P.155 (寸法表)

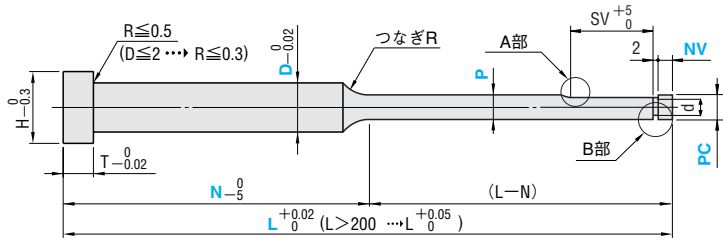
赤枠内 P寸法範囲を一部修正

P	d	L-N	SV
1.50~2.49	P-0.2	$30 \leq L-N \leq 50$	15
2.50~3.99	P-0.4	$50 < L-N$	30
4.00~6.00	P-0.6
